Addendum No. 3
December 14, 2021

Project: Harrisburg High School - 9th Grade Academy
Sioux Falls, South Dakota
Architecture Incorporated Project #2904

Architect: Architecture Incorporated

4) SHEET 4.32 – DOOR DETAILS

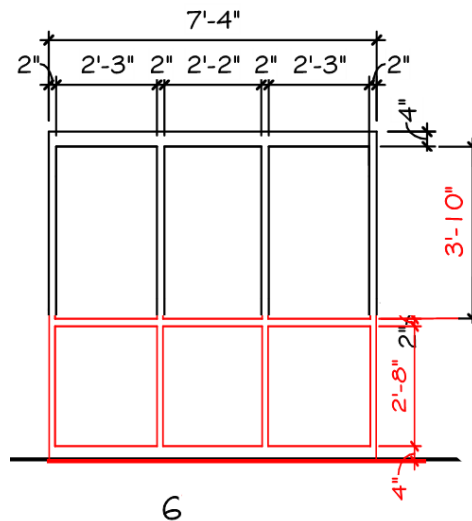
- a) **CORRECTION:** Addendum #2 Item 40) a) i) (1) incorrectly noted that the borrowed lite frames in Area E conference rooms E116, E117, E216 & E217 are to be borrowed lite Type 4.

- i) The borrowed lite frames in Area E conference rooms E116, E117, E216 & E217 are to remain borrowed lite **Type 6, but as modified per Addendum #2**, as verbally described per Addendum #2 Item 40) a) ii) and as shown below:
